Access Compliance Report

Public Rights-of-Way

Intersection ID: 13314	Main Street: BALGREEN_CT	Cross Street: BIEDERBECK_DR	Location: SE
ADA ID: DCBF4D72A82B	Ramp Type: PerpDiag	Initial Pass/Fail: Fail	Overall Compliance: No
		Severity Score: 17.5

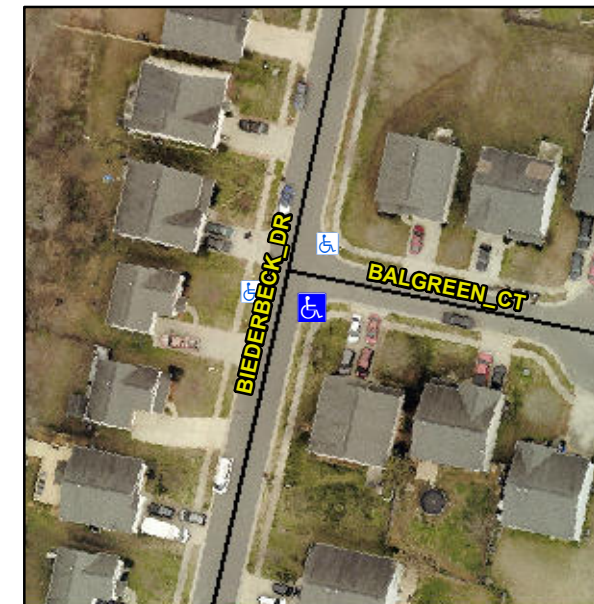
Not Found, R304.5.1

Compliance	Description	Data	Compliance	Description	Data
N/A	Ramp Length (in)	49.0	Yes	Ramp Slope (%)	6.2
No	Ramp Width (in)	33.0	Yes	Ramp XSlope (%)	0.3
N/A	Flare Type LT	N/A	N/A	Flare Type RT	N/A
N/A	Flare Slope LT (%)	N/A	N/A	Flare Slope RT (%)	N/A
N/A	Flare Traversable LT?	N/A	N/A	Flare Traversable RT?	N/A
N/A	Landing Length (in)	N/A	N/A	DWS Provided?	N/A
N/A	Landing Width (in)	N/A	N/A	DWS Contrast?	N/A
N/A	Landing Slope (%)	N/A	N/A	DWS Length (in)	N/A
N/A	Landing X Slope (%)	N/A	N/A	DWS Full Width?	N/A
N/A	Landing Curb? (Y/N)	N/A	N/A	DWS Offset (in)	N/A
N/A	Shared Landing?	N/A			
N/A	Gutter Ponding?	N/A	N/A	Gutter Slope (%)	N/A
N/A	Gutter Lip Ht (in)	N/A	N/A	Gutter X Slope (%)	N/A
N/A	Painted X Walk1?	No	N/A	Painted X Walk2?	No
	X Walk 1 Direction	To NW		X Walk 2 Direction	To NE
N/A	X Walk 1 Width (in)	N/A	N/A	X Walk 2 Width (in)	N/A
	X Walk 1 Slope (%)	3.1		X Walk 2 Slope (%)	3.3
	X Walk 1 X Slope (%)	2.7		X Walk 2 X Slope (%)	2.9

Remove & Replace Curb Ramp With Two New Directional Ramps or Equivalent.
